TVA-BFN-TS-425

**BROWNS FERRY NUCLEAR PLANT (BFN) - UNITS 2 AND 3 - TECHNICAL  
SPECIFICATIONS (TS) CHANGE 425 - FRAMATOME FUEL - CORE OPERATING  
LIMITS REPORT (COLR) REFERENCES**

Proposed Technical Specifications Changes (mark-up)

5.6.5 CORE OPERATING LIMITS REPORT (COLR)

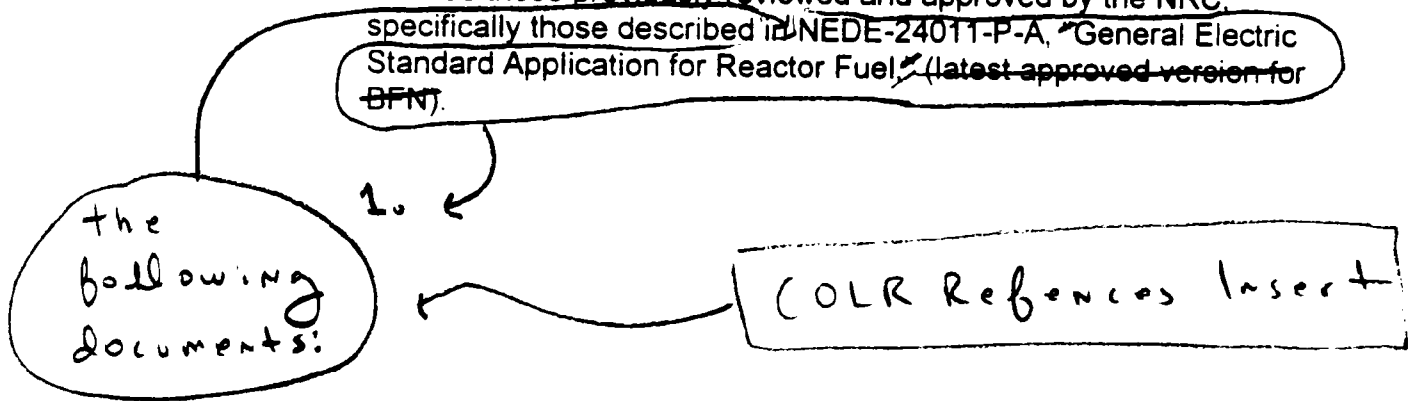
- b. The analytical methods used to determine the core operating limits shall be those previously reviewed and approved by the NRC, specifically those described in NEDE-24011-P-A, "General Electric Standard Application for Reactor Fuel," (latest approved version for BFN).

### **COLR References Insert**

2. XN-NF-81-58(P)(A), RODEX2 Fuel Rod Thermal-Mechanical Response Evaluation Model.
3. XN-NF-85-67(P)(A), Generic Mechanical Design for Exxon Nuclear Jet Pump BWR Reload Fuel.

4. EMF-85-74(P)(A), RODEX2A (BWR) Fuel Rod Thermal-Mechanical Evaluation Model.
5. ANF-89-98(P)(A), Generic Mechanical Design Criteria for BWR Fuel Designs.

6. XN-NF-80-19(P)(A) Volume 1, Exxon Nuclear Methodology for Boiling Water Reactors - Neutronic Methods for Design and Analysis.
7. XN-NF-80-19(P)(A) Volume 4, Exxon Nuclear Methodology for Boiling Water Reactors: Application of the ENC Methodology to BWR Reloads.

8. EMF-2158(P)(A), Siemens Power Corporation Methodology for Boiling Water Reactors: Evaluation and Validation of CASMO-4/MICROBURN-B2.
9. XN-NF-80-19(P)(A) Volume 3, Exxon Nuclear Methodology for Boiling Water Reactors, THERMEX: Thermal Limits Methodology Summary Description.

10. XN-NF-84-105(P)(A) Volume 1, XCOBRA-T: A Computer Code for BWR Transient Thermal-Hydraulic Core Analysis.
11. ANF-524(P)(A), ANF Critical Power Methodology for Boiling Water Reactors.

12. ANF-913(P)(A) Volume 1, COTRANSA2: A Computer Program for Boiling Water Reactor Transient Analyses.
13. ANF-1358(P)(A), The Loss of Feedwater Heating Transient in Boiling Water Reactors.

14. EMF-2209(P)(A), SPCB Critical Power Correlation.
15. EMF-2245(P)(A), Application of Siemens Power Corporation's Critical Power Correlations to Co-Resident Fuel.

16. EMF-2361(P)(A), EXEM BWR-2000 ECCS Evaluation Model.
17. EMF-2292(P)(A), ATRIUM™-10: Appendix K Spray Heat Transfer Coefficients.
